REFERRAL REPORT

Report Date: September 7, 2021
Contact: Yardley McNeill
Contact No.: 604-873-7582
RTS No.: 14593
VanRIMS No.: 08-2000-20
Meeting Date: September 21, 2021

TO: Vancouver City Council
FROM: General Manager of Planning, Urban Design and Sustainability
SUBJECT: CD-1 Rezoning: 1157 Burrard Street

Figure 3 – Site Plan

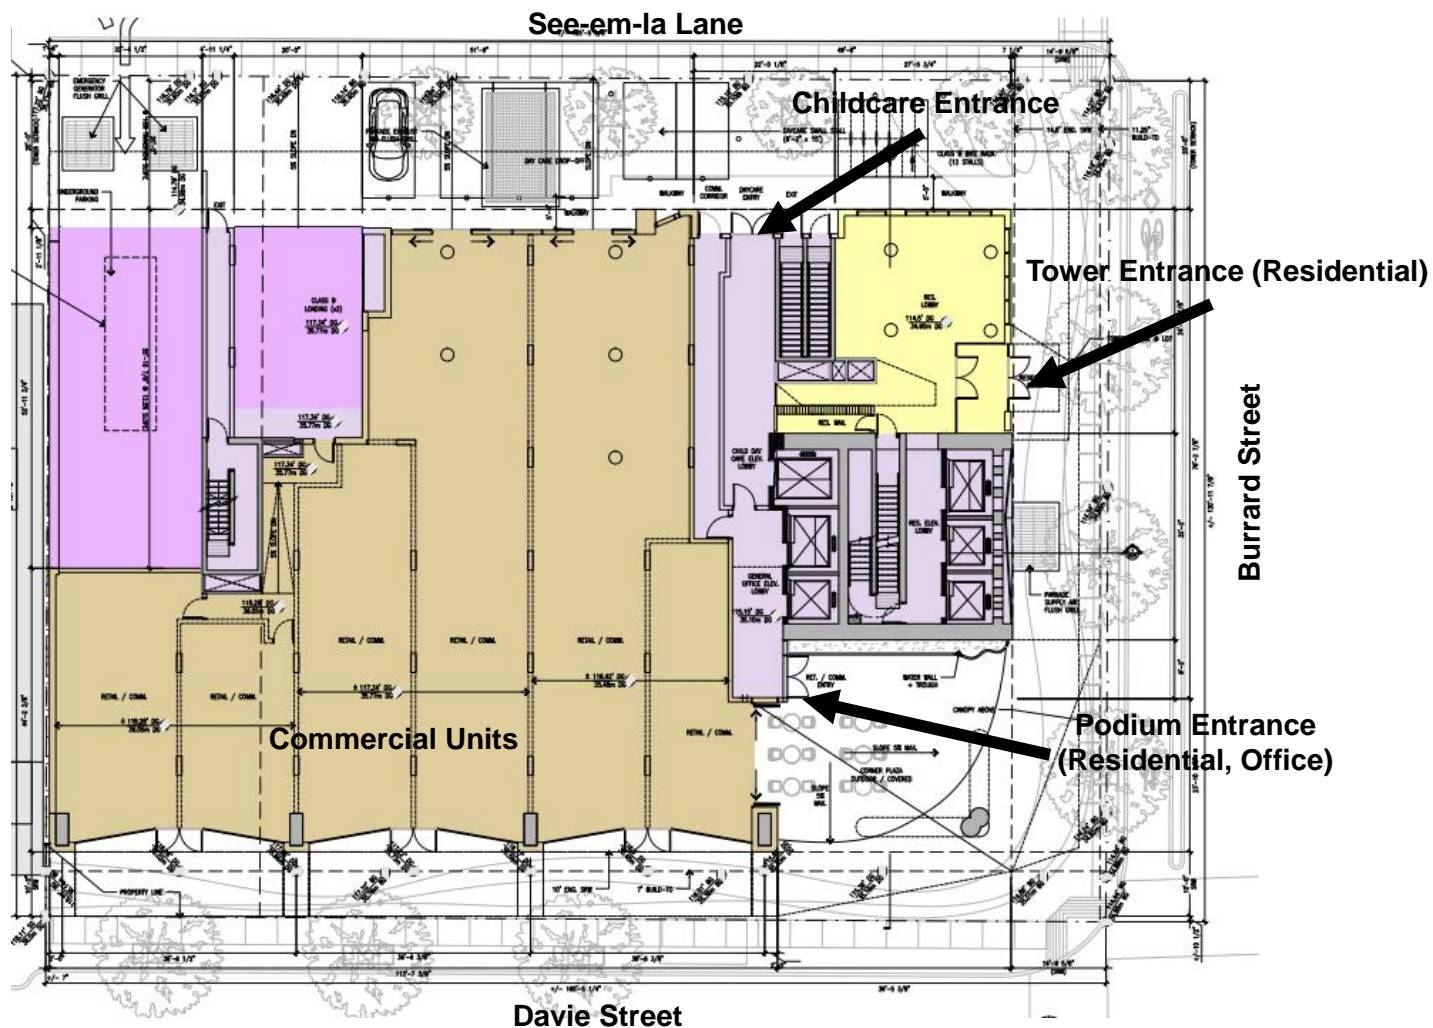
The residential lobby is accessed from Burrard Street. Residential units are on levels four and above. Commercial units are at ground level fronting Davie Street. The vehicular access and loading is from the See-Em-La Lane. Indoor and outdoor amenity areas for all residents of the building are located on level seven and the roof. The proposed site plan is included in Figure 3 and is subject to conditions as outlined in Appendix B.

Figure 5 – Davie Street (south) Elevation

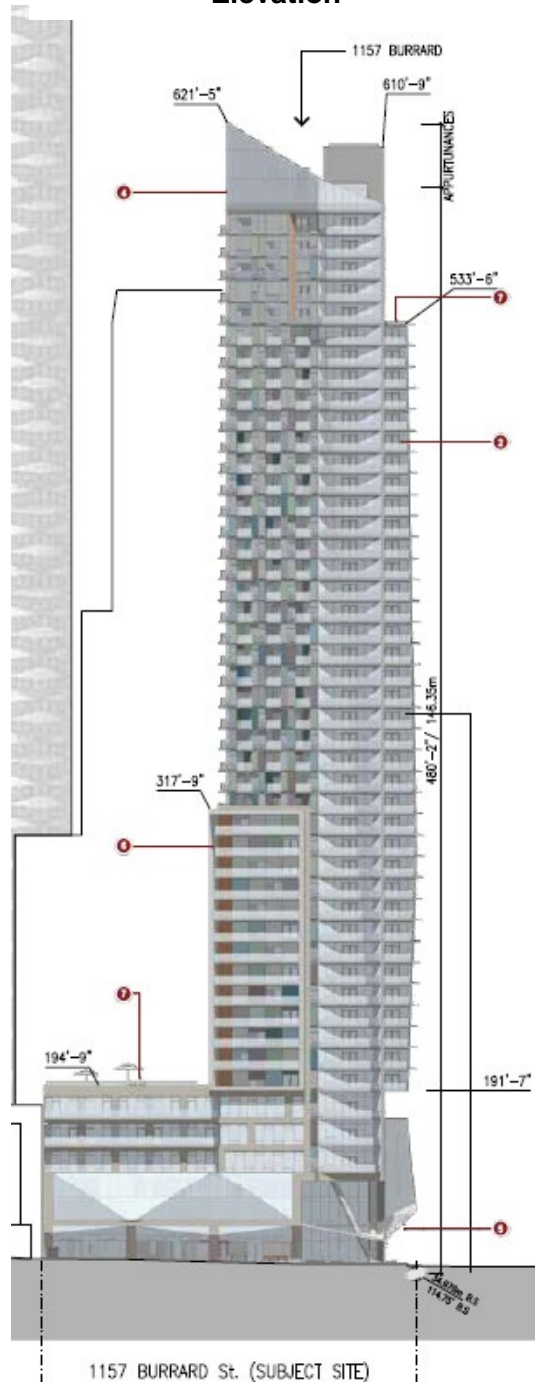
Staff have evaluated the quality of the proposed public open space, have compared it to other *HBP* proposals, and have concluded that substantial design development is needed, including improvements to the ground plane, podium expression, and commercial frontage to further complement the urban culture of Davie Village.

Figure 6 - Shadow Study at Spring / Fall Equinoxes

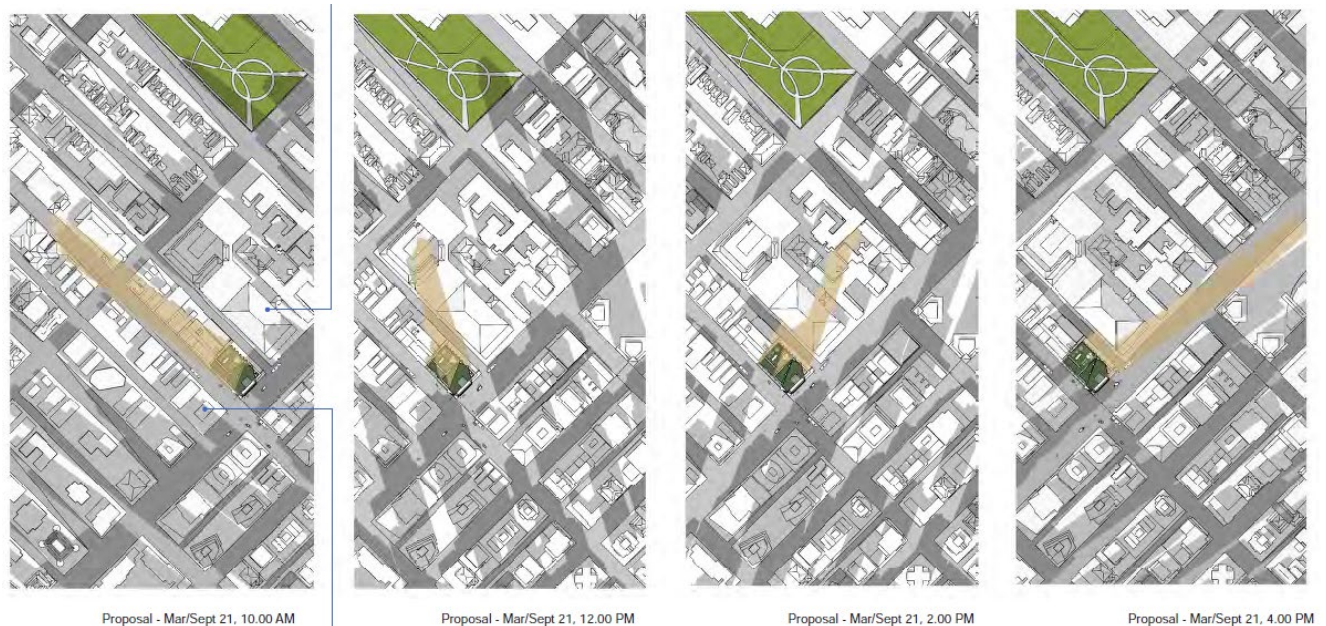
Shadowing - Shadowing of public open spaces and village areas is a critical consideration of both the *West End Community Plan* and the *HBP* in order to secure the long-term vitality of these important urban places, particularly when residents and visitors are most active. Overshadowing is assessed at 10am, 12pm, 2pm, and 4pm during the spring/fall equinoxes and summer solstice. Staff have assessed that the morning overshadowing will not unduly affect the environment of Davie Village.
